URGENT: MEDICAL DEVICE RECALL

Research Instruments is voluntarily recalling the power supply cable for the Integra 3™ micromanipulator. Research Instruments internal testing has discovered a minor materials fault with the power supply cable (2-54-031). Our records show the affected products were shipped to your facility.

Integra 3 Internal Power Cable Replacement

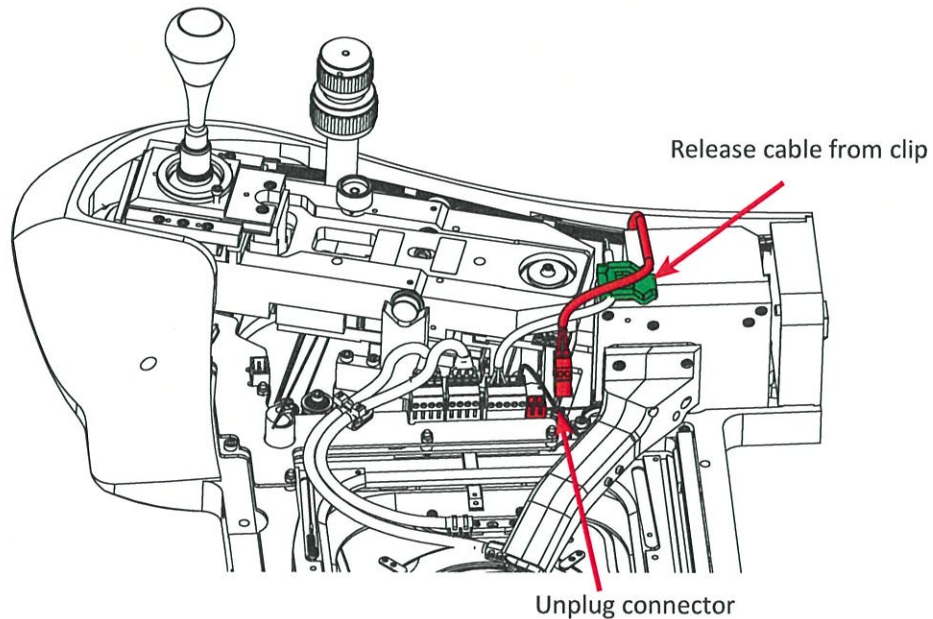
2. The power cable is located underneath towards the rear of the Integra 3 (the cable, connector and socket are shown in red below).

Look underneath the Integra 3 for the row of orange connectors/sockets shown below. Unplug the 2-way connector nearest the back which contains only a red and black wire. There are no clips to release. Ensure that the correct connector is unplugged.

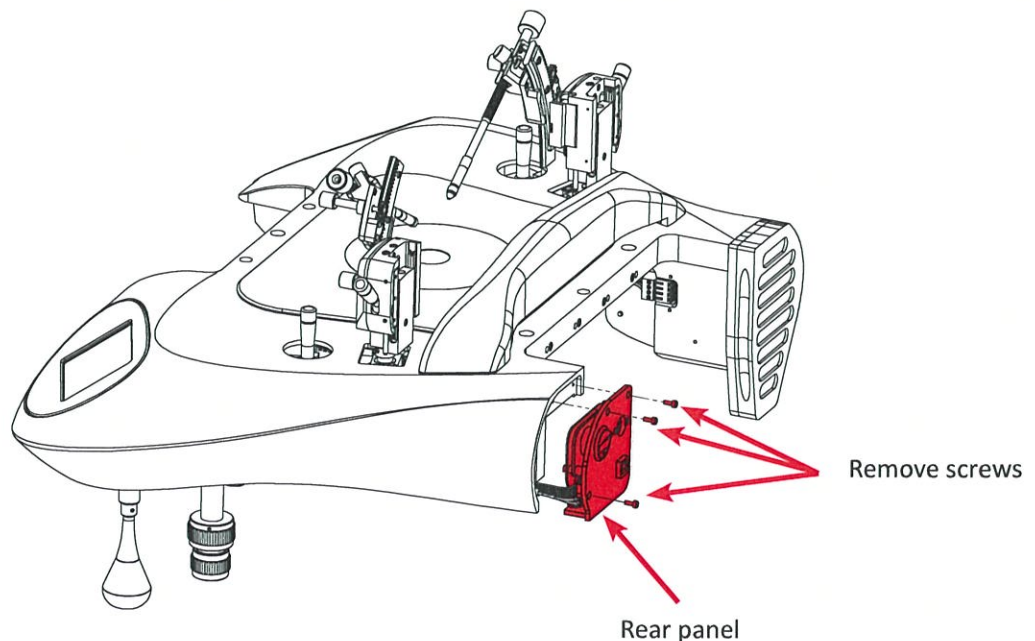
Release the power cable from underneath the white clip located on the surface of the Thermosafe Heater Module, (the cable clip is shown in green below), and from any other clips that retain the cable.

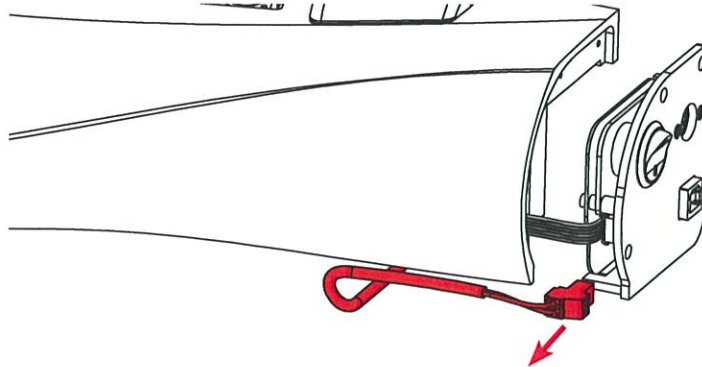
4. Unplug the 2-way orange power cable connector, the lower of the two cables, by pulling on the connector. There are no clips to release. If you find it difficult to get hold of the connector it may be necessary to pull on the cable.

Take care not to damage or pull on the other cable attached to the rear panel assembly.

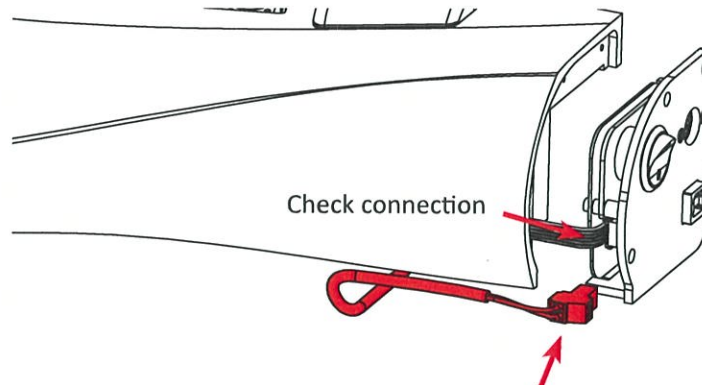
5. Once the cable is removed, plug a new power cable (Part No. 2-54-031) into the rear panel assembly. Both ends of the cable are identical so either end can be used. Note that the connector can only be plugged in one way round: the screw terminals in the connector should face towards the rear panel. When inserting the connector, a positive click should be heard as the connector clips into position. It is important that the connector is fully inserted.

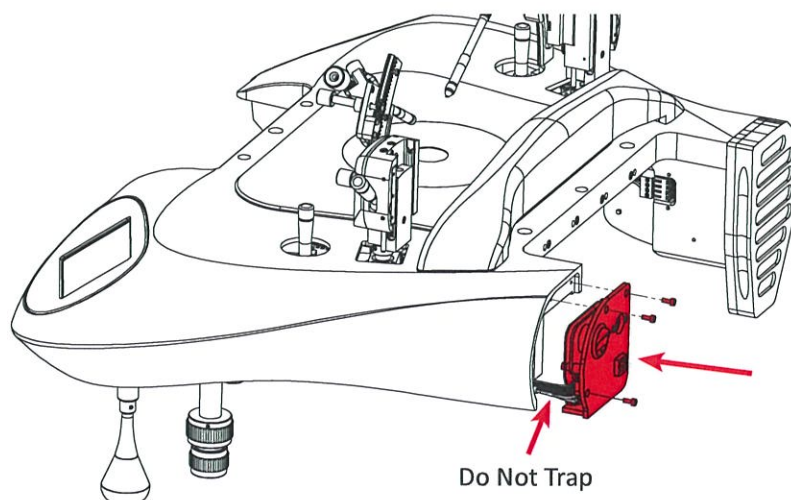
Take care not to damage or pull on the other cable attached to the rear panel assembly. Check that the red connector is still clipped firmly into its socket.

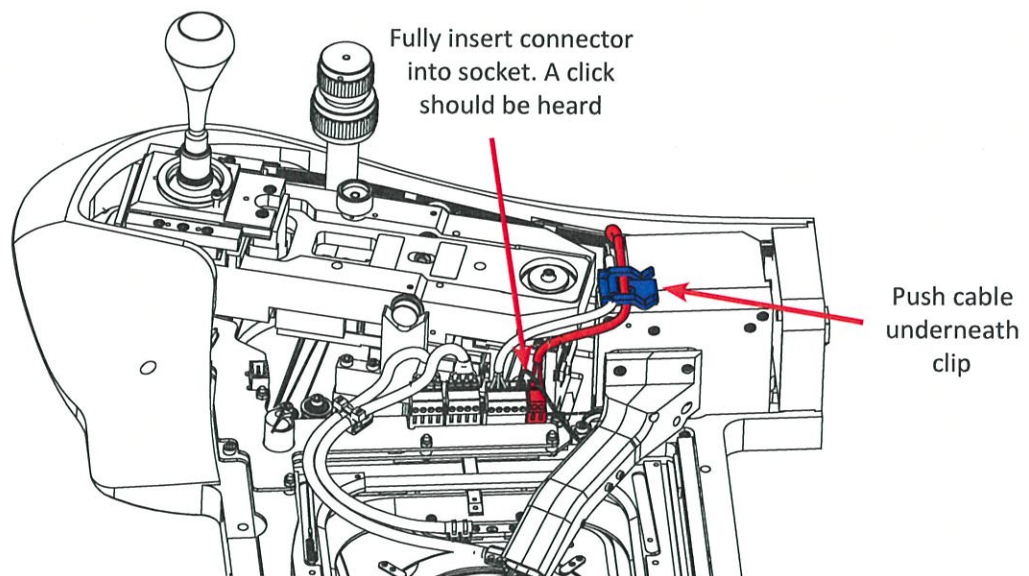
7. Working beneath the Integra 3, plug the 2-way orange connector on the new power cable into the 2-way socket nearest the back of the Integra 3. Note that the connector can only be plugged in one way round: the screw terminals in the connector should face towards the centre of the Integra 3. When inserting the connector a positive click should be heard as the connector clips into position. It is important that the connector is fully inserted.

Route the cable underneath the cable clip on the surface of the Thermosafe Heater Module.
